LANE COVE COUNCIL SUBMISSION

Ref: SSD-81941461

Infill Affordable Housing **12-20 Berry Road and 11-19 Holdsworth Avenue St Leonards**

Figure 4 -Extent of Building Setback Variations to Holdsworth Avenue (Building to the Right) and Berry Road (Building to the Right).

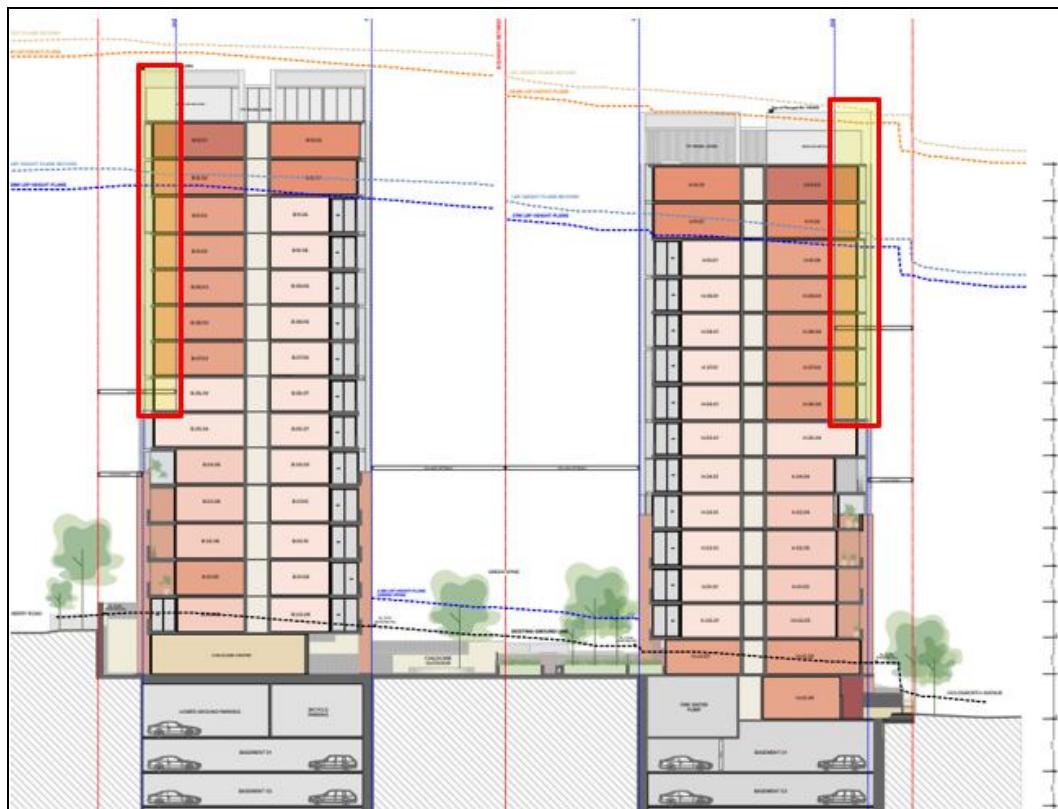
- There are substantial variations being proposed to the required **minimum 7m setback** for both buildings **at Level 6 and above to Berry Road and Holdsworth Avenue** (see Figure 4).

Figure 5 -Extent of Building Variations to the East-West Pedestrian Link (Area 16)

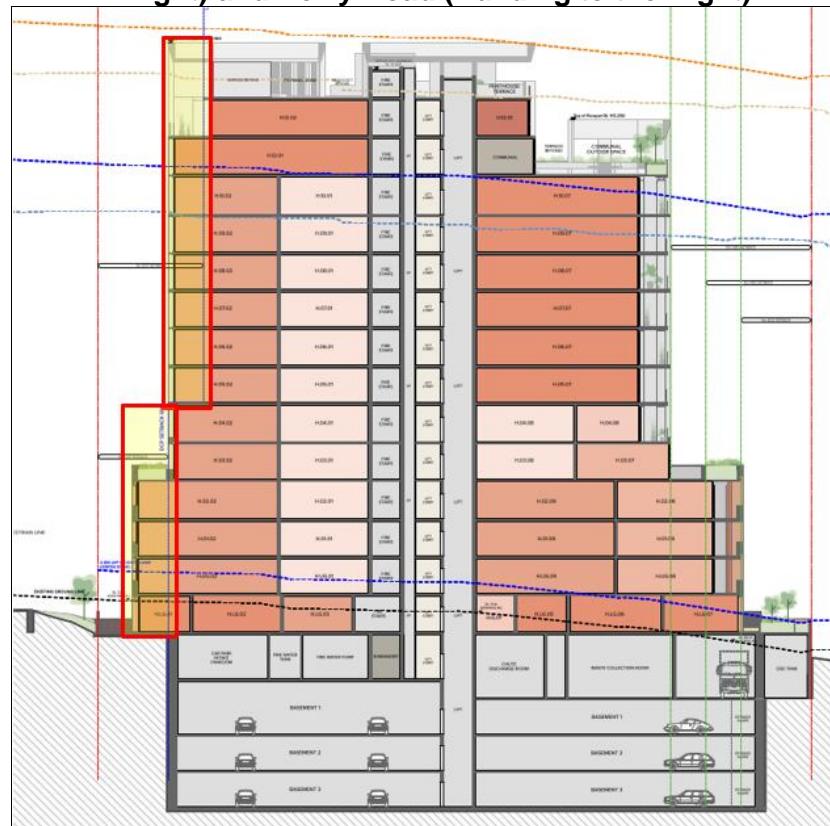
- There are substantial variations being proposed to the required **minimum 6m and 9m setback** for both buildings to 15m wide pedestrian link (see Figures 5 and 6 below).
- The building setback controls have been carefully considered at the strategic planning stage to ensure that the bulk and scale of buildings are appropriate to the relevant public domain interfaces and to correspond across the whole precinct, including specific relevant street and pedestrian link characteristics. Any departures from the building setback map and associated tables would result in an inconsistent built form within the Precinct itself.
- Full compliance would ensure that any approval would reflect the expectations of the community that Council's newly adopted site-specific and precinct wide DCP be fully complied with which went through an extensive strategic planning and community consultation process.

Figure 6 - Deep Soil Plan – Areas incorrectly included as total deep soil marked in red.

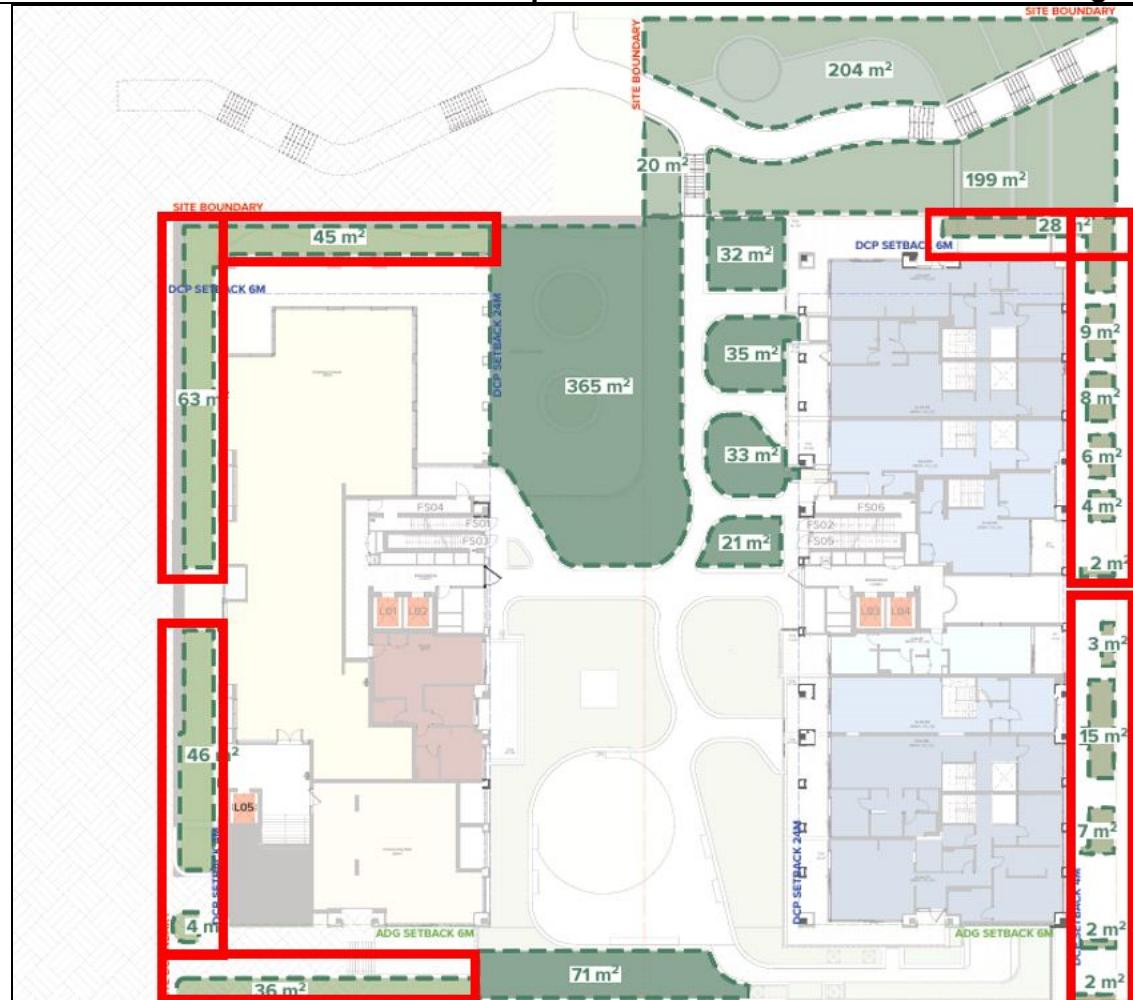
An analysis of the deep soil plan with mark-ups in red identifying the non-compliant areas which have classified as deep soil can be found in Figure 6 below. The non-compliant deep soil is approximately 280m². The total deep soil calculation after removing the non-compliant areas is 980m² or approximately 19.5% of the site. This would result in inadequate Soil Area and Volume within the Berry Road and Holdsworth Avenue Setback Area for establishing Trees successfully over the long term.

Figure 8 and 8A- Tower/Area 17 proposes 15 storeys (left) and Tower/Area 16 proposes 14 storeys (right) and do not comply with the LCDCP + SEPP bonus which permits a maximum of 13 storeys.

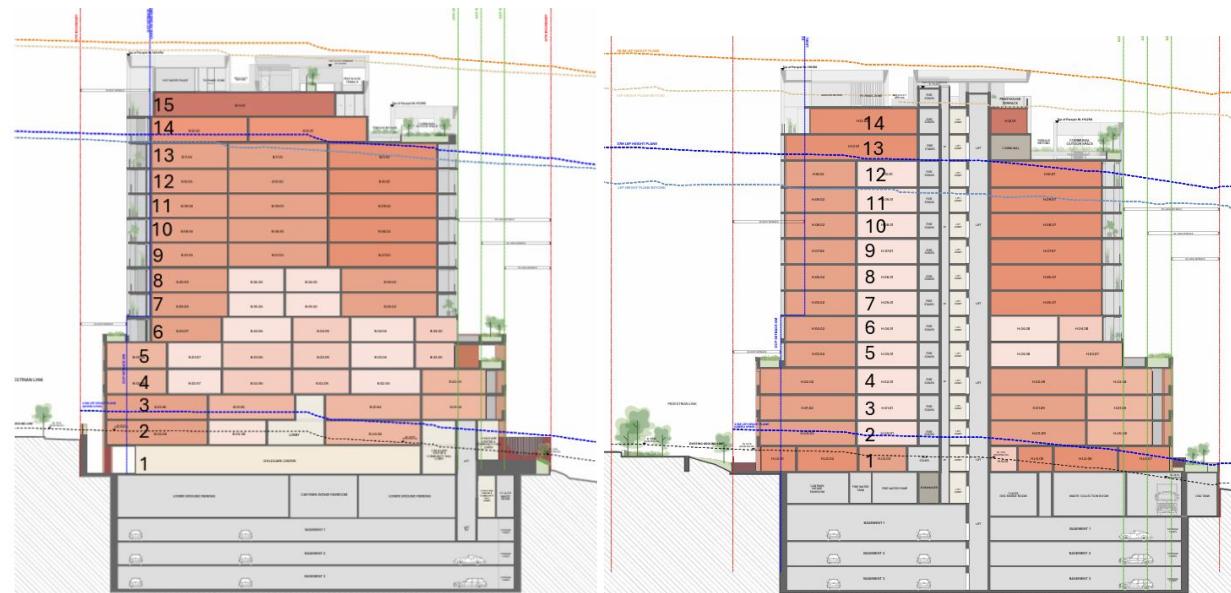
The application is seeking to incorporate affordable housing and utilise the 30% height and floor space ratio bonus available under Chapter 2 of the State Environmental Planning Policy (Housing) 2021 (Housing SEPP). A 30% increase to the 10-storey height control would permit a **maximum of 13 storeys** for area/tower 16 and area/tower 17.
